Re: Zircaloy Clad  
Conversion  
ISAP Topic 2.17

Haddam Neck Plant  
Additional Information  
Small-Break Loss of Coolant Accident Analysis--  
Zircaloy Clad Fuel

Attachment  
Haddam Neck Plant  
Additional Information

FIGURE 7-12

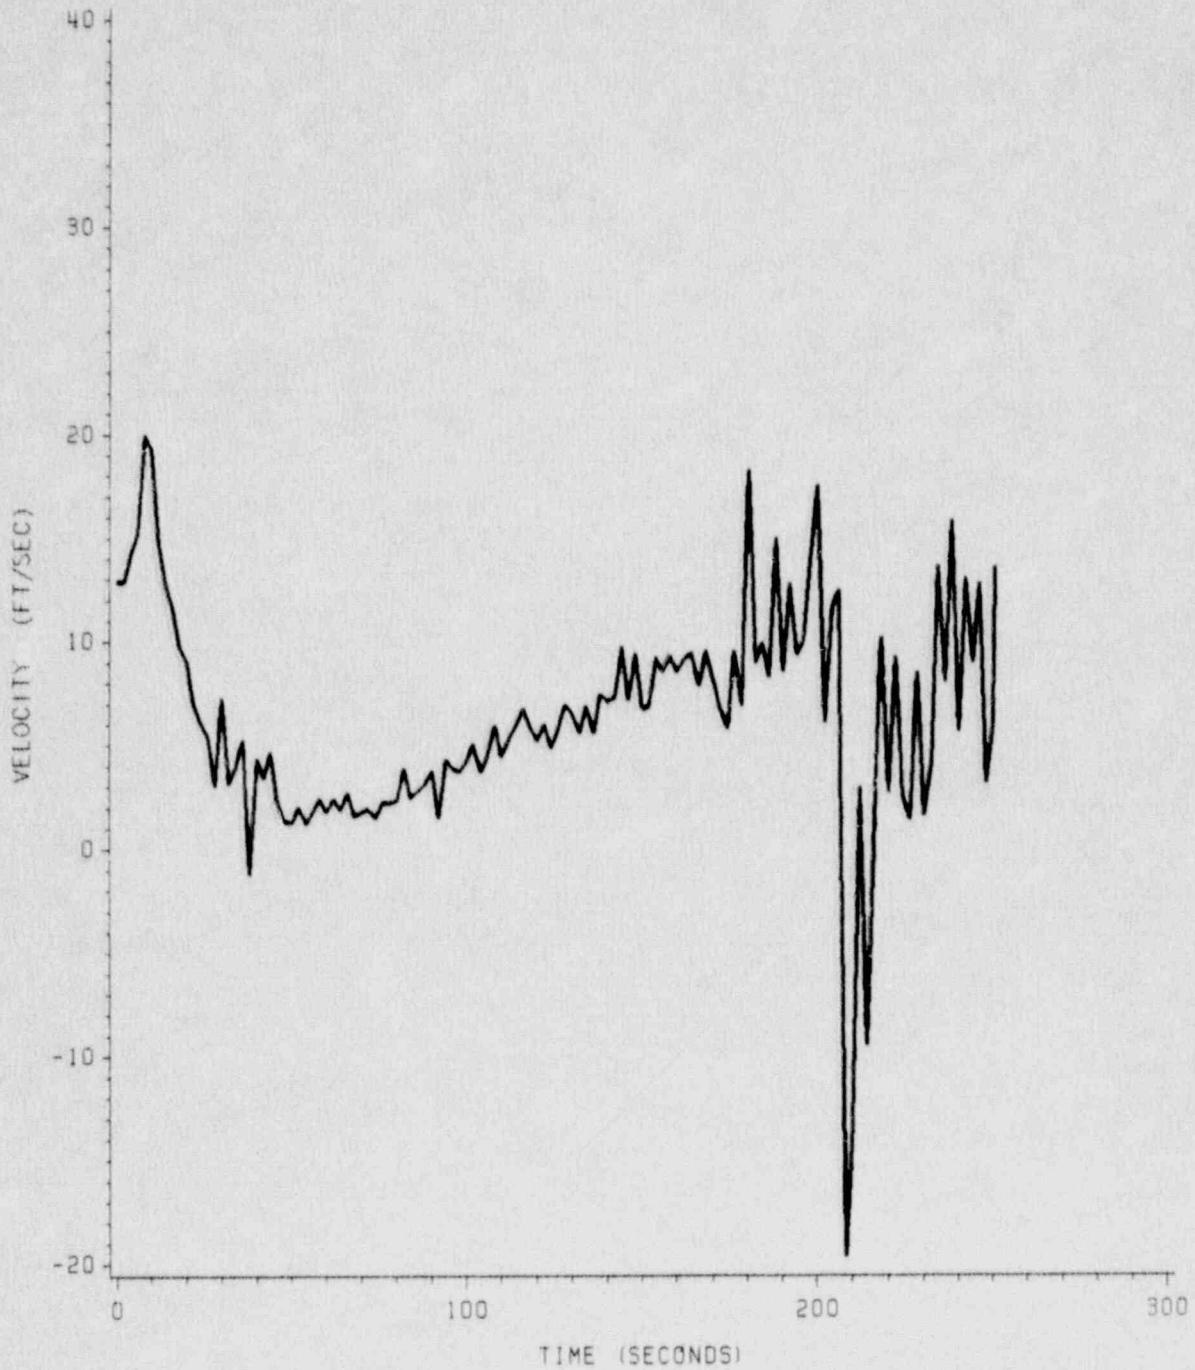
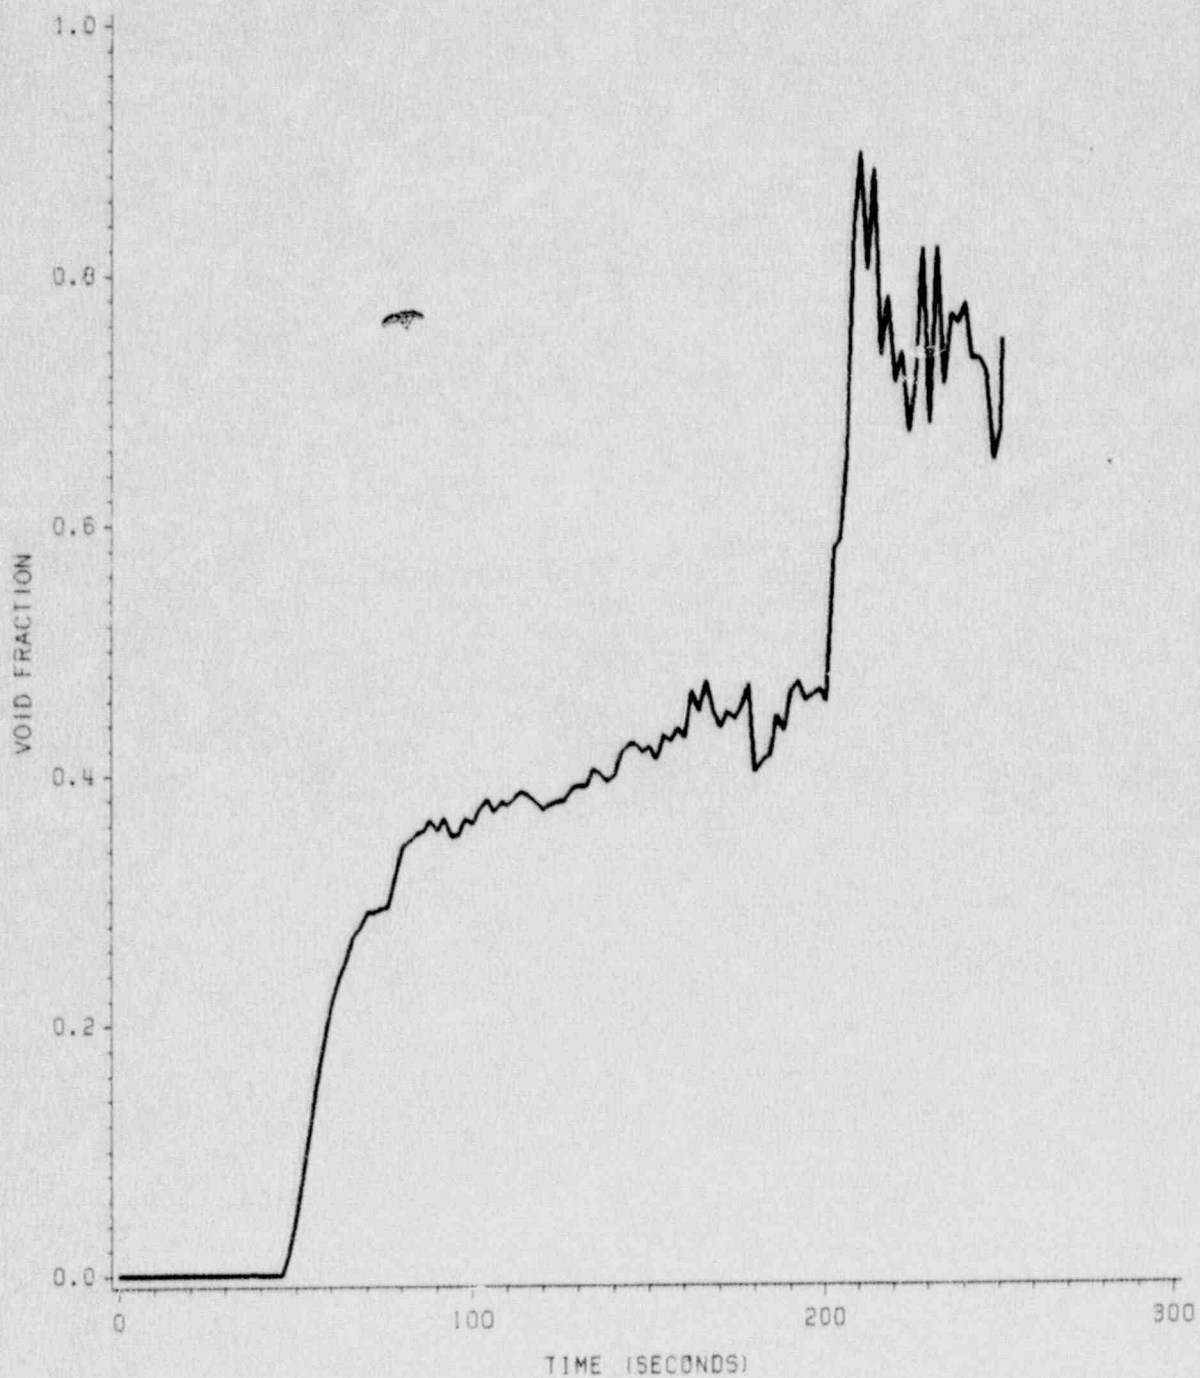
By letter dated August 3, 1988, the staff provided a safety evaluation of the use of the NULAP5 code. Conclusion 7 of the evaluation stated that the licensee committed to review the core thermal-hydraulics and clad temperature response in all future calculations to ensure that the clad temperature increase is not artificially terminated by the existence of mist flow in the upper core during the loop seal clearing uncovering period. Provide evidence of this review.

The clad surface temperatures are provided in NUSCO 163. Collapsed and two-phase level plots are provided in the response to Question 8. Figures 7-1 through 7-12 provide the hot spot vapor velocity and void fraction in lower plenum volume 335 for each of the breaks analyzed in NUSCO 163.

The collapsed and two-phase level plots provide the time frame for the loop seal clearing uncovering period. It can be seen from the clad temperature responses that the clad temperature increase is terminated during or subsequent to the core level recovery period following loop seal clearing for each of the breaks analyzed. In order to terminate the clad temperature increase during the loop seal clearing uncovering period, a sudden increase in hot spot vapor velocity would have to occur resulting in an increase in heat transfer coefficient. An increase in hot spot vapor velocity could potentially be calculated to occur if the lower plenum volume 335 significantly voided as core level approached the minimum value. Generally, the void fraction in volume 335 would have to be greater than approximately 0.6 for this phenomenon to occur. The lower plenum volume 335 void fraction plots provided verify that the void fraction never approaches 0.6 during the loop seal clearing uncovering period.

Based on the above, it was concluded that, for each of the breaks analyzed in NUSCO 163, the clad temperature increases were not artificially terminated by the existence of mist flow in the upper core during the loop seal clearing uncovering period and that no additional analysis was required.
